# UNITED STATES PATENT AND TRADEMARK OFFICE

10/652,110

# Office Action Summary

## DETAILED ACTION

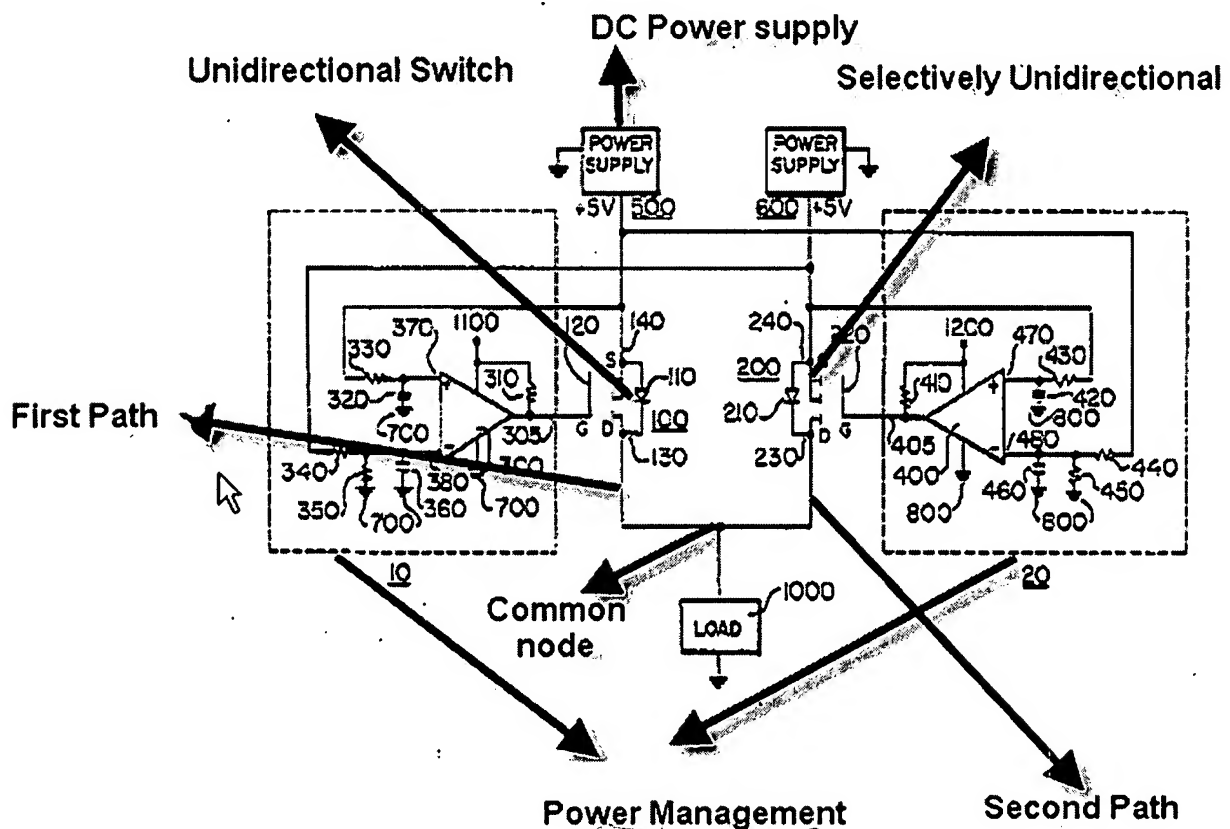
2. Claim 1 is rejected under 35 U.S.C. 102(b) as being anticipated by Williams (US 5,536,977).

Regarding Claim 1, Cowan et. al. discloses in Figures 1-3, a power supply topology comprising:

A first path (see figure above) configured to be coupled to a controllable DC power source (C1); a second path (see figure above) configured to be coupled to a rechargeable battery (B1); a third path (see figured above) configured to be coupled to a system load (see figure 4), wherein said first, second, and third paths are coupled to a common node; a unidirectional switch (140) coupled to said first path to allow selective coupling of said controllable DC power source to said system load via said common node; and a selectively unidirectional switch (240) coupled to said second path to allow selective coupling of said battery to said common node; a power management control circuit (10 and 20)n configured to control the conduction state of said unidirectional switch ( see figure above, 110) to a closed position to enable said controllable DC power source to supply power to said system load via said common node (see figure above) , said power management control circuit is further configured to control the conduction state of said selectively unidirectional switch (see figure above, element 220) to a first closed position to enable said rechargeable battery to supply power to said system load via said common node and to prevent a current flow from said controllable DC power source to said rechargeable battery (noted that the diodes that are presented with the switches are served to protect any reverse currents going into the power supplies) ; wherein when said unidirectional switch is in said closed position and said selectively unidirectional switch is in said first closed position, said controllable DC power source and said rechargeable battery are coupled in parallel (See column 1, lines 50-54, Claims 6 and 11)
